STAFF REPORT
WEST ALLIS PLAN COMMISSION
Wednesday, June 28, 2023
6:00 PM

- 4A. Conditional Use Permit for Caribou Coffee, a proposed Restaurant with accessory drive-through service, at 10200 W. National Ave.**
- 4B. Site, Landscaping, and Architectural Design Review for Caribou Coffee, a proposed Restaurant with accessory drive-through service, at 10200 W. National Ave. (Tax Key No. 485-9990-013)**

Site Plan

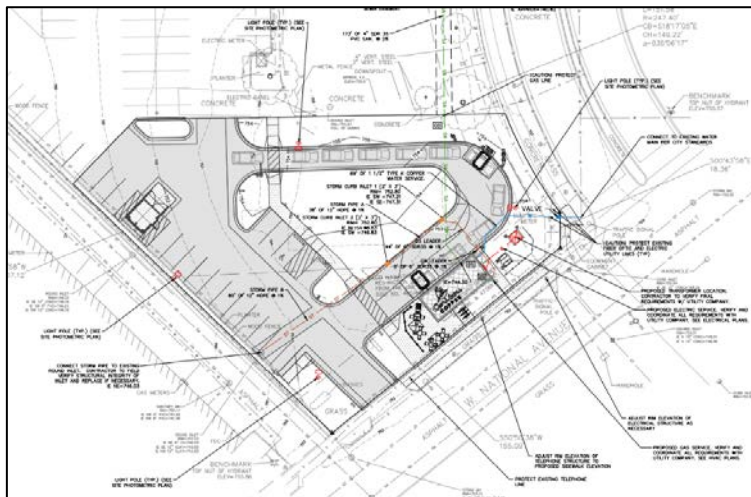
The proposed building is situated 10.2’ from the front lot line, within the maximum setback per Sec. 19.42. The building includes a drive-through window on the rear, north side of the building and a walk-up window on the front, south side of the building. An outdoor dining patio is located adjacent to the building and includes connections to the public sidewalk.

The proposed site layout includes 18 vehicle parking stalls (including 1 ADA stall) and 1 bicycle rack. The existing portion of the site includes 23 parking stalls and is legally nonconforming. Per code upon time of the application, restaurants were allowed the equivalent to 1 space per 40% of the building's occupancy. In this case, the maximum number of vehicle parking spaces would be 2. Per current code of 1 per 150 sq. ft., the maximum would be 4. Caribou is eligible for the less restrictive standard. The Plan Commission may approve the parking as is because it is a reduction in nonconformity or may condition a further reduction in parking. If Plan Commission desires a further reduction, staff would recommend removing the 3 parking spaces between the refuse enclosure and the northern lot in favor of landscaping.

The proposed drive-through is oriented around a central landscaping island. From the crosswalk leading to the north, the drive-through includes stacking for 10 vehicles; 6 to the order kiosk situated at the beginning of the curve and 4 to the pick-up window. A bail-out lane is included adjacent to the order kiosk. The City's Design Guidelines require that drive-throughs be located at the side or rear of the building, which this proposal adheres to. It also requires driveways for drive-throughs be located as far as possible from street intersections and be located on secondary streets for corner lots. This lot's driveway is pre-existing on the main street but is located far from the intersection. Staff recommends maintaining this site layout as proposed.

1. Common Council approval of the Conditional Use Permit.
2. Common Council approval of a Certified Survey Map to split parcel into 2 lots.
3. Revisions to Site, Landscaping, and Architectural plans showing a) additional landscape plantings along the north side of the property; b) scale drawings of landscape beds; c) landscaping species plan approved by City Forestry; d) sidewalk alignment for connection with property to the north.

Landscaping Plan

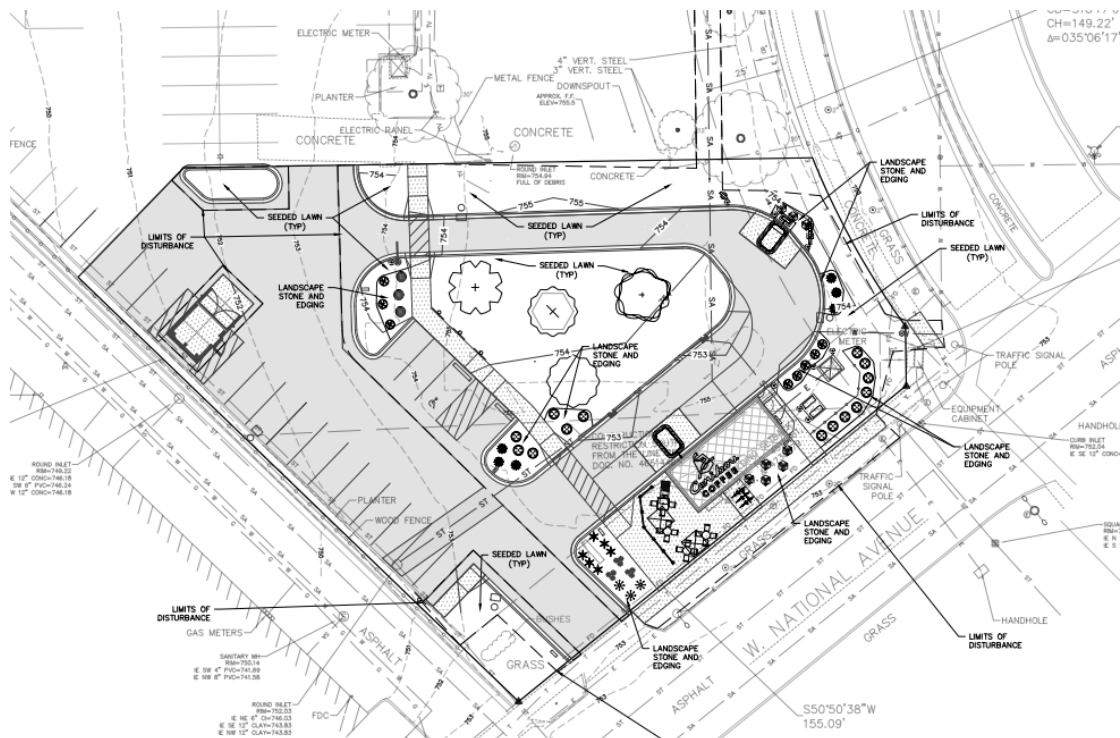
The proposed site layout includes a significant increase in the amount of landscaping. A new landscaping island is proposed at the north edge of the site and another is extended at the southwest corner of the site. A large, triangular landscaping bed is proposed at the center of the site.

Plantings include deciduous shrubs and perennial flowers near the building, arborvitae to screen the drive-through and service door from W. National Ave., and trees and other shrubs in the central landscaped island. City Forestry recommends additional landscaping along the North edge of the property and updated scaled drawings to better determine spacing and quantity of plantings.
